SERVICE BULLETIN

COOLING Caravan 3110

Ignition Problems RM 7XX1 and RM 7XX5!

Publication-No.: 599 5202-38 en / Service 2004.06.14 BO/ KV

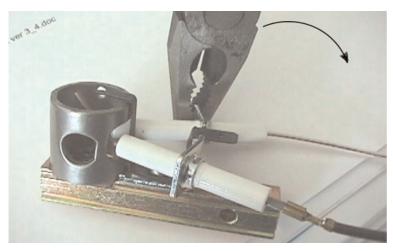
Due to production tolerances it might happen that the space between the ignition plug and the bottom of the burner housing is too small. Thus, a correct ignition is not always possible, as the spark might jump over to the burner housing.

In case another gas malfunction is indicated, the burner control device has to be changed.
